Location of Construction: 40 Russey Sound Rd, Peaks Isl		Owner: Asbornsen, Morten	Phone: 228-0033	Permit No: 981380
Owner Address: ***** P.O. Box 56 Peaks, Isl ME 04108		Lessee/Buyer's Name:	Phone:	BusinessName:
Contractor Name: SAA		Address:		Phone:
Past Use: 1-fam	Proposed Use: Same	COST OF WORK: \$ 3,000.00	PERMIT FEE: \$ 35.00	<div style="border: 2px solid black; padding: 5px; text-align: center;"> PERMIT ISSUED Permit Issued: DEC - 9 1998 </div> <div style="border: 2px solid black; padding: 5px; text-align: center;"> CITY OF PORTLAND </div>
		FIRE DEPT. <input type="checkbox"/> Approved <input type="checkbox"/> Denied	INSPECTION: Use Group R3 Type: 5/3 DOCA96	
Proposed Project Description: Amend Permit #980953 Add dormer window to 3rd fl & porch & deck on 1st fl		Signature: _____ Date: _____		
Permit Taken By: MG		Date Applied For: 25 November 1998

BUILDING PERMIT REPORT

DATE: 5 Dec. 98 ADDRESS: 40 Hussey Sound Rd. P.T. CBL 089-E-001
REASON FOR PERMIT: To Const. Dormer / Porch deck (A mend. To #980953)
BUILDING OWNER: R. Morten
CONTRACTOR: [Signature]
PERMIT APPLICANT: [Signature]
USE GROUP R-3 BOCA 1996 CONSTRUCTION TYPE 5B

REASON FOR PERMIT: Construct Dormer, Porch & Deck

FIRST FLOOR FRAMING

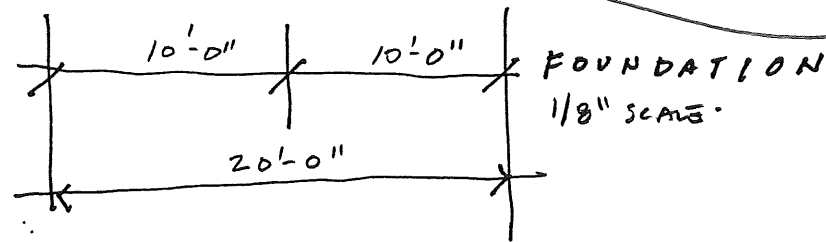
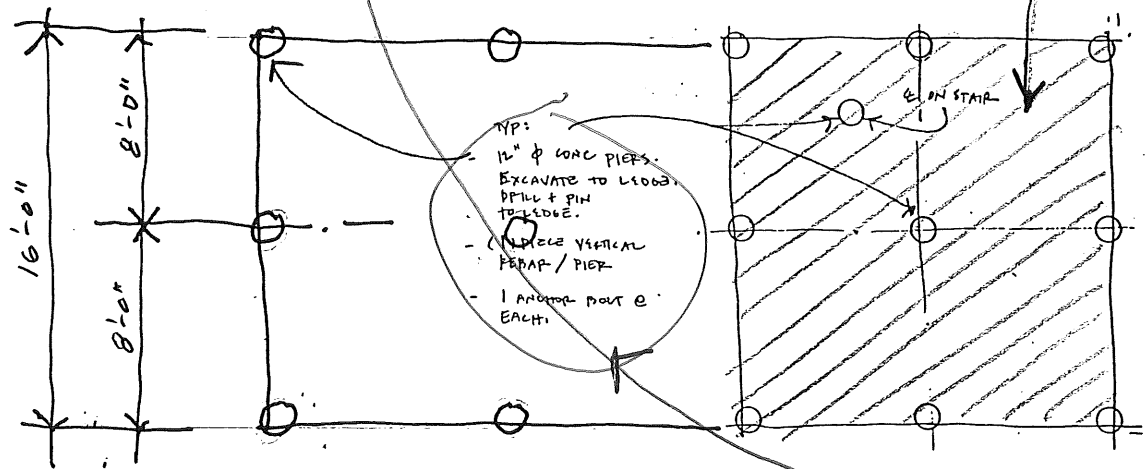
42 Live Load
 2 spans 3
 8' span. 1 of 1 - 11/16/98

672
 bridging
 required

714 OK
